Gibbons Creek Environmental Redevelopment Group, LLC

September 6, 2022

Re: Technical NOD2 New CCR Registration  
Gibbons Creek Environmental Redevelopment Group, LLC – Anderson, Grimes County  
New Coal Combustion Residuals (CCR) Registration No. CCR113  
Industrial Solid Waste Registration No. 32271  
EPA Identification No. TXD000751073  
Tracking No. 27262344; RN100214550/CN6505860162

FIGURE  
FIGURE 4

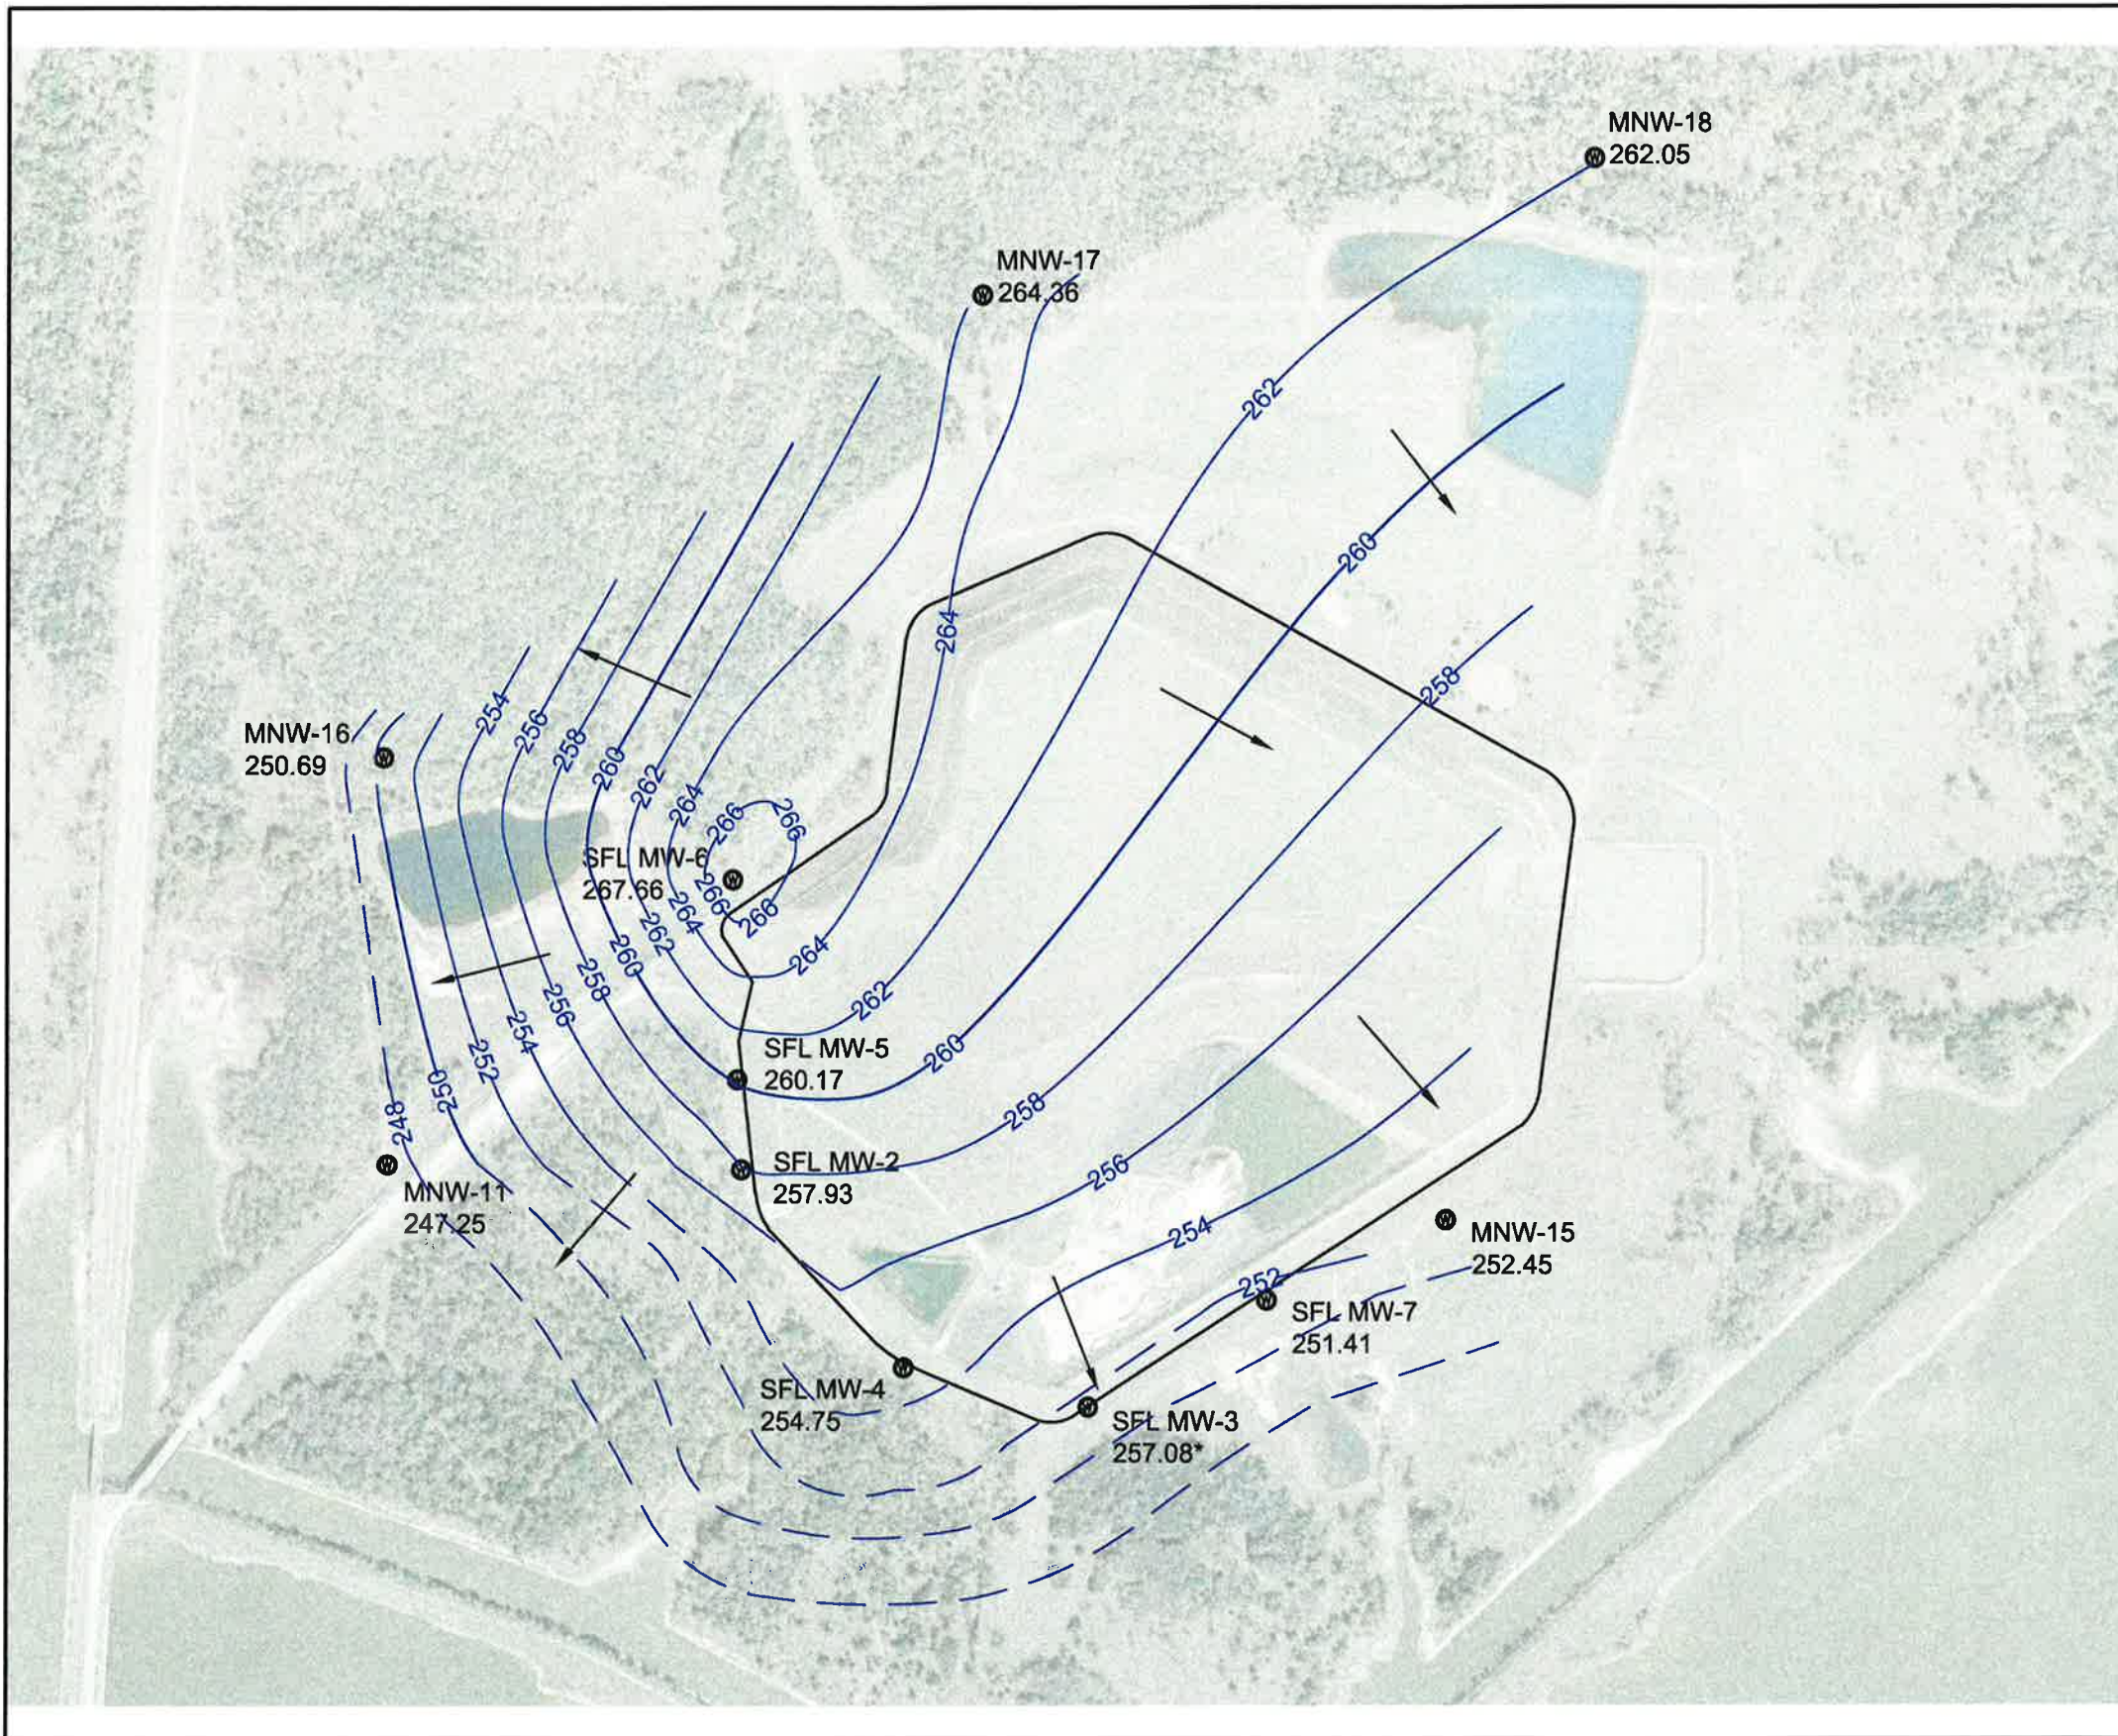
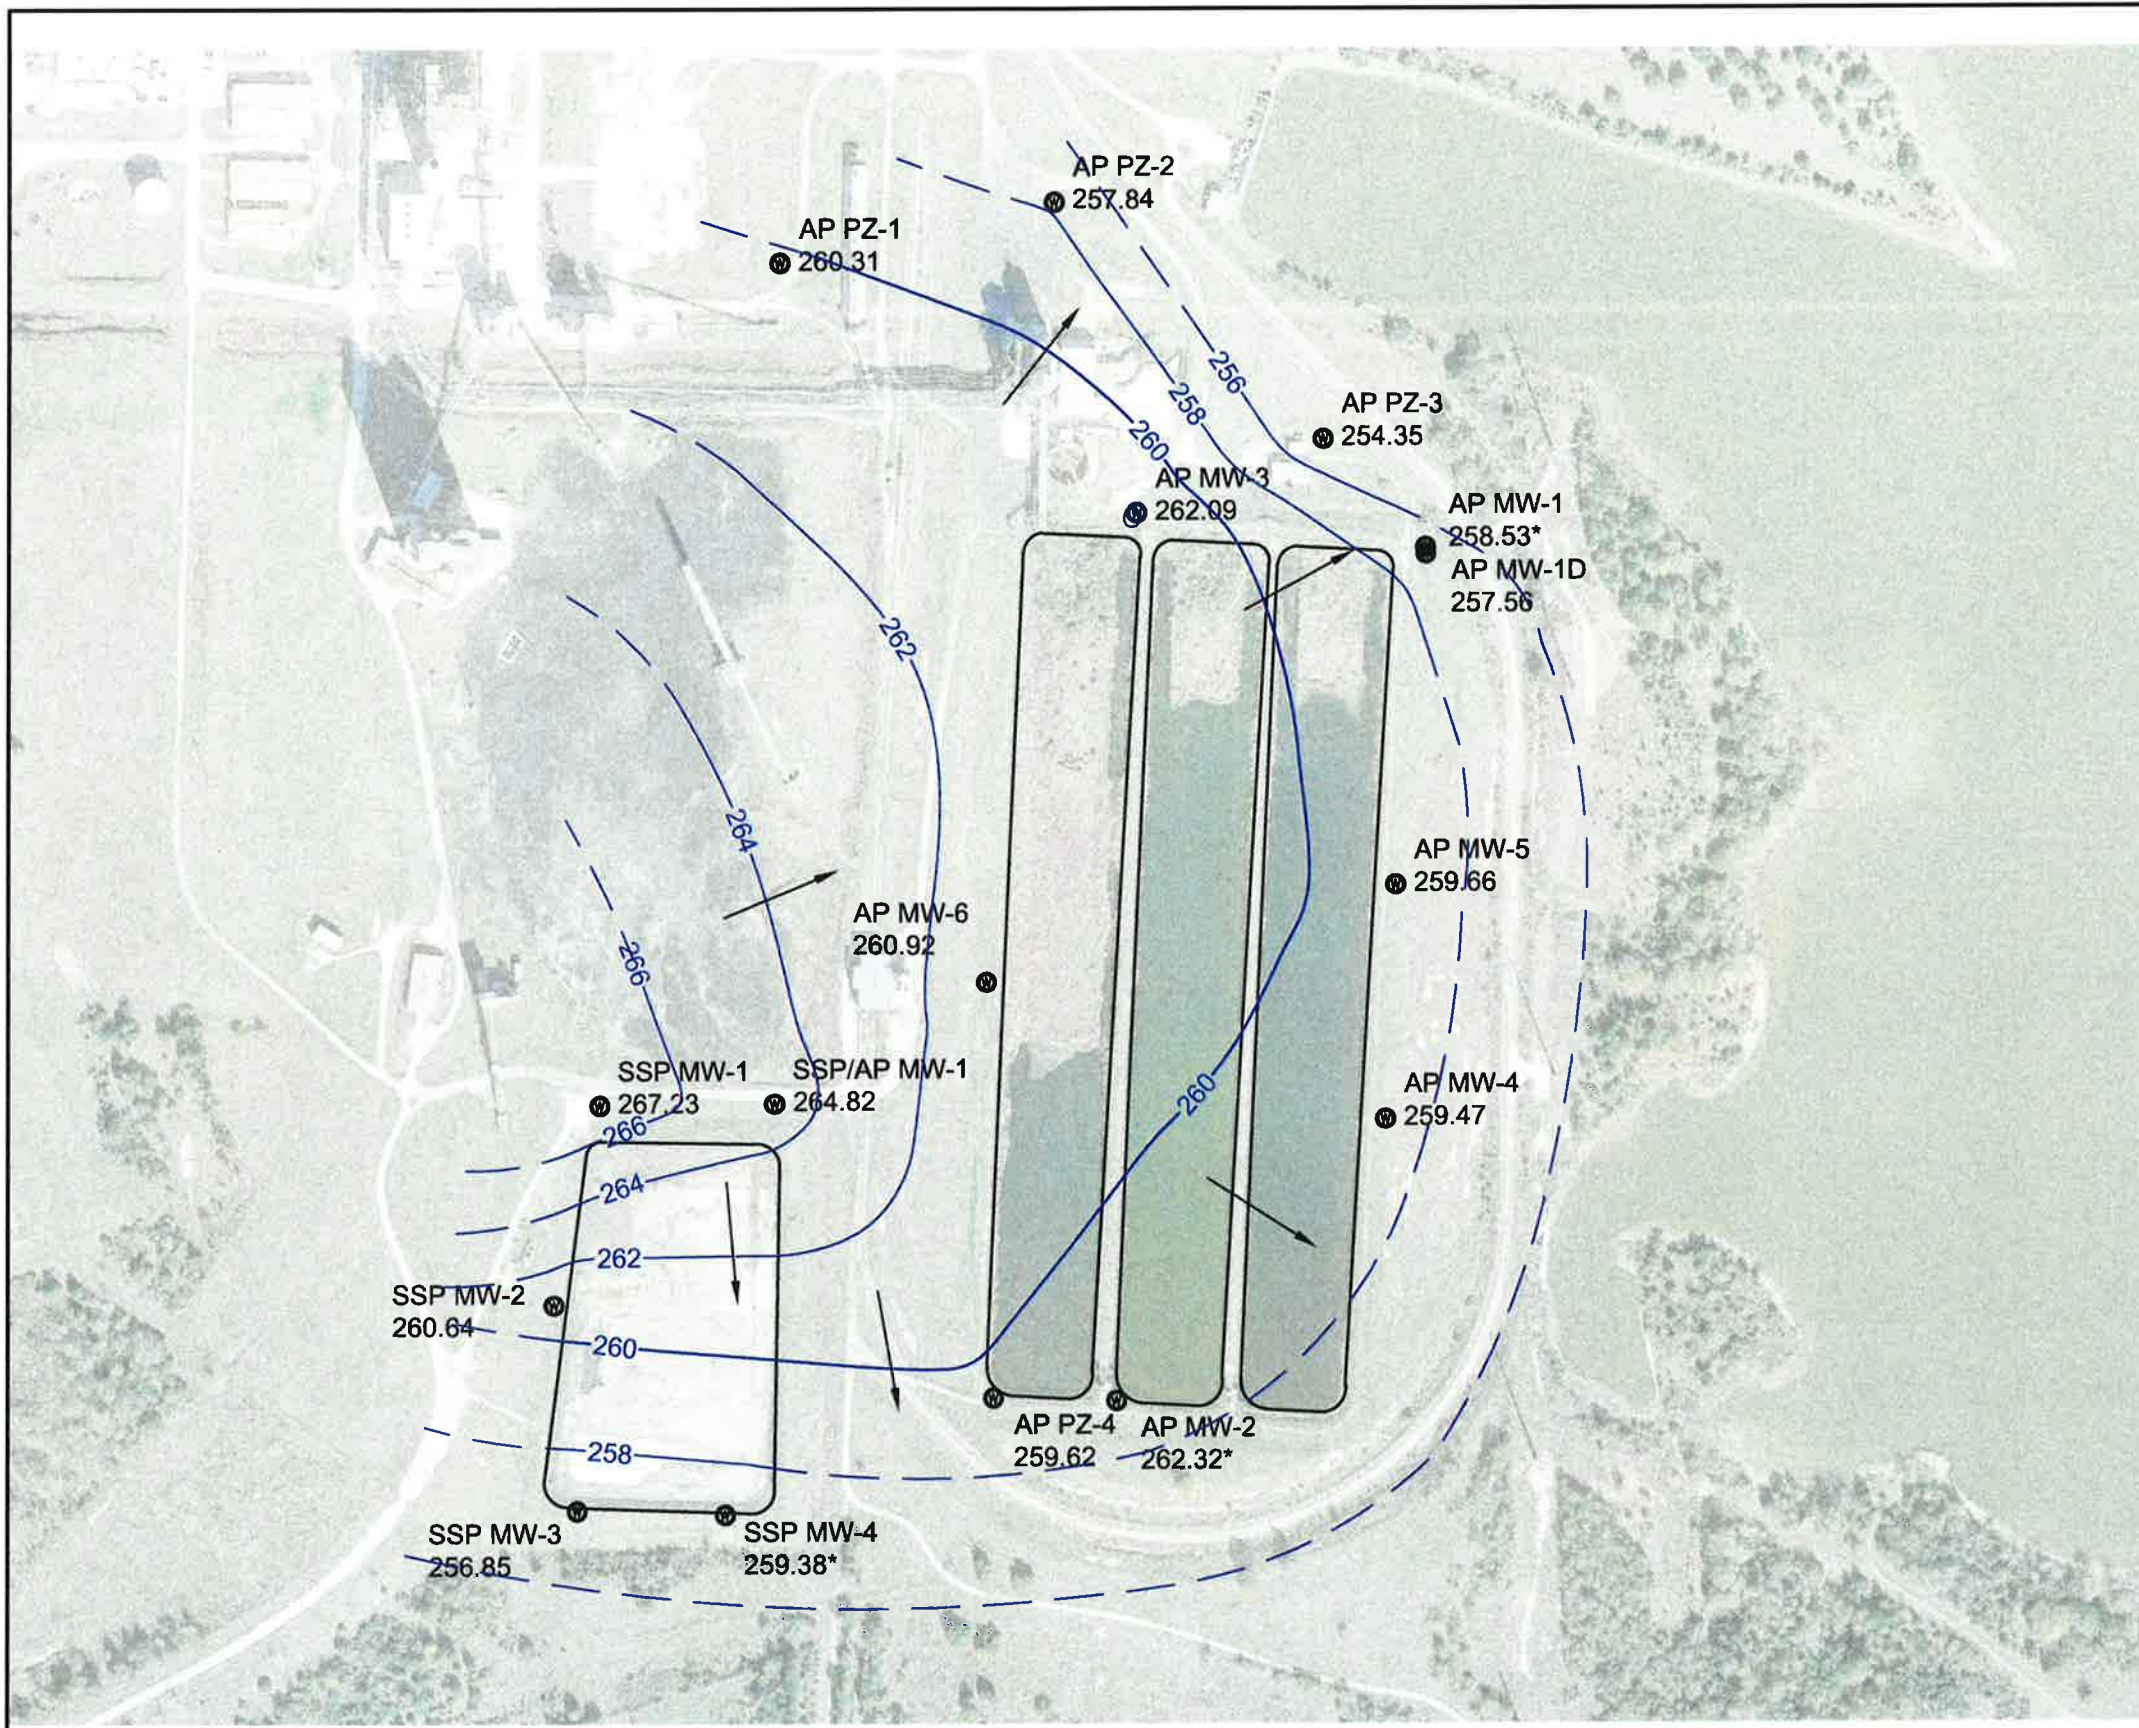
Provide reports and figures signed and sealed by a P.E.

*See response Item 22 Attachment for revised reports and figures.*
